Flywheel Replacement – 1991 40 (4 Cylinder)

1991 Mariner and Mercury 40 (4 Cylinder)
Serial Number

US 0D055048 thru 0D071436
Belgium 9665165 thru 9670909

Figure 1. Cast Iron Flywheel

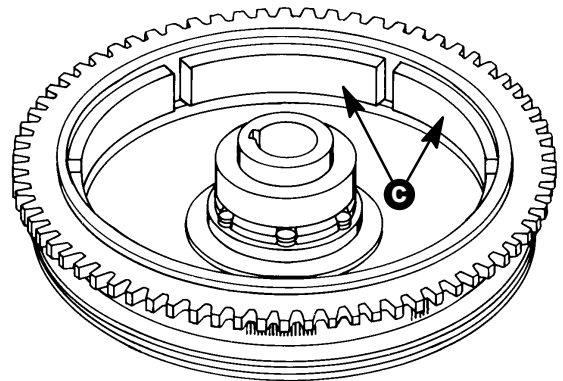
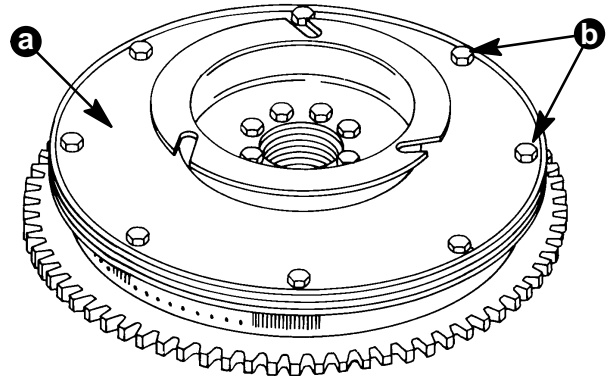
Outboards listed, require replacement of the cast iron flywheel, (Figure 1) with a new style flex plate flywheel (Figure 2). The cast iron flywheel has the potential to cause the crankshaft to flex under certain load/engine speed conditions, resulting in damage to the labyrinth seal of the upper reed block.

a - Cast Iron Flywheel (No Flex Plate) - Must be Replaced

1. Replace cast iron flywheel with new style flex plate flywheel. Refer to Section 2A of Service Manual P/N 90-814676 for flywheel removal and installation instructions. Torque flywheel nut to 75 lb. ft. (101.7 N-m).
2. Refer to Section 2C of service manual and perform steps as listed under "Timing/Synchronizing/Adjusting".
3. Scrap cast iron flywheel, as it must not be used.

Figure 3. Earlier Style Flex Plate Flywheel - Do Not Use On Models Listed

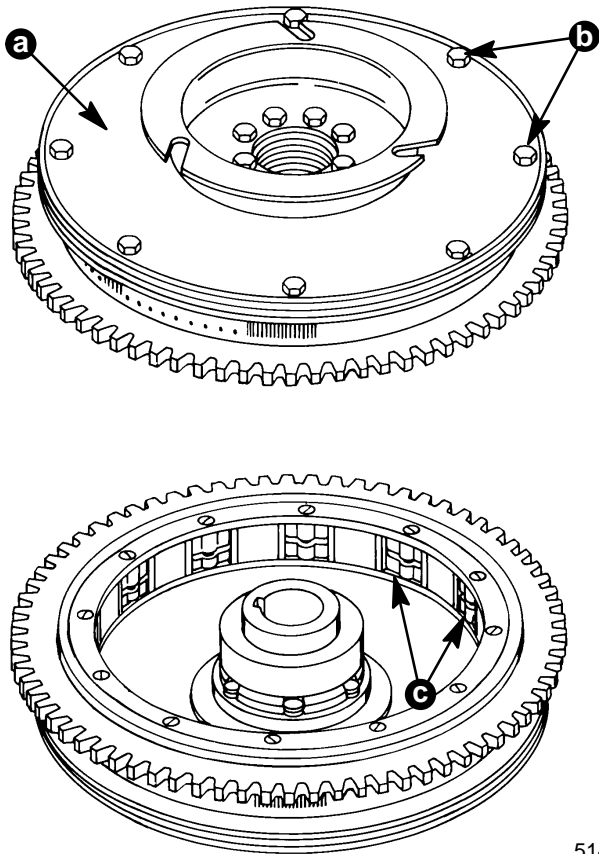
DO NOT use the earlier style flex plate flywheel (Figure 3) on models listed, as the polarity of the flywheel magnets is not compatible with the present stators.

Figure 1. Cast Iron Flywheel Must Be Replaced

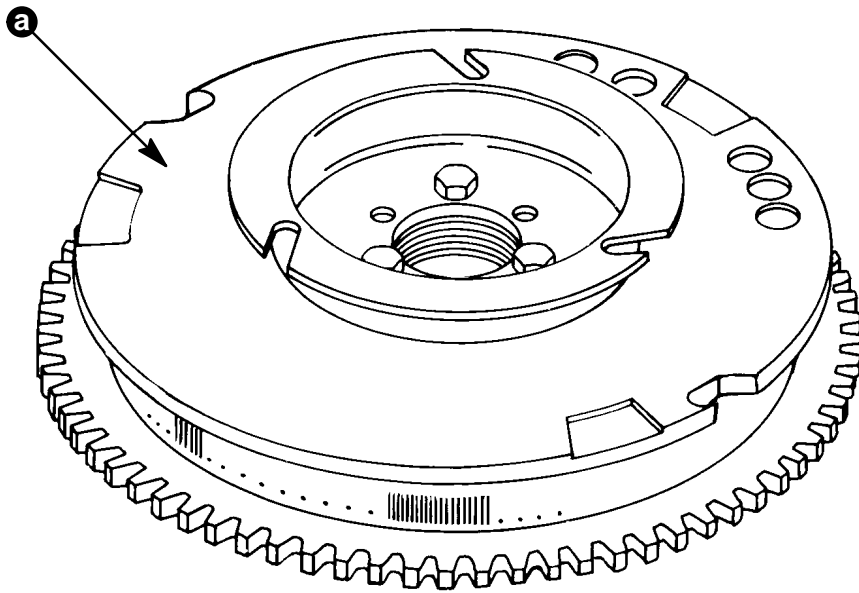
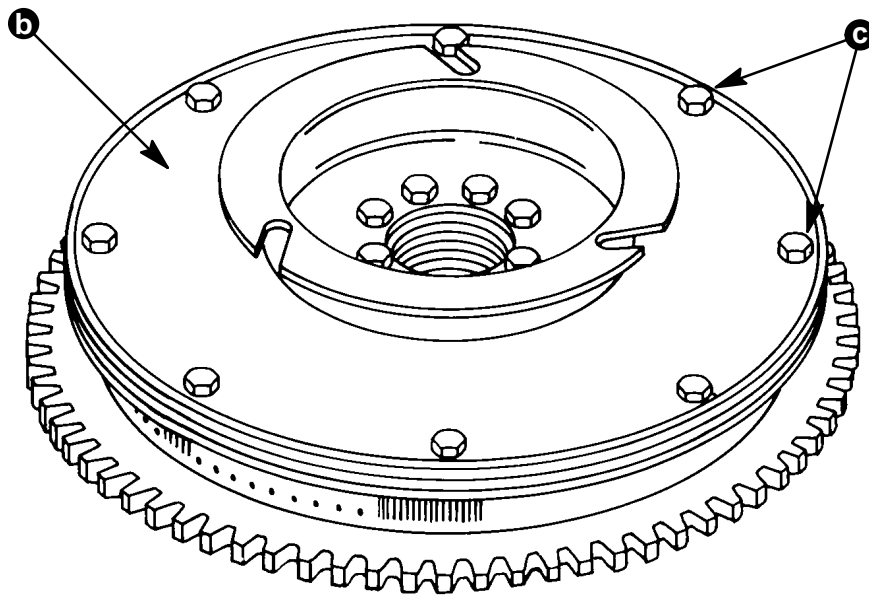
Some flywheels were replaced at the factory and can be identified as illustrated on the reverse side of this letter.

a - Cast Iron Flywheel (No Flex Plate or Bolts)

b - Flex Plate
c - Bolts

Figure 2. New Style Flex Flywheel - No Replacement Required
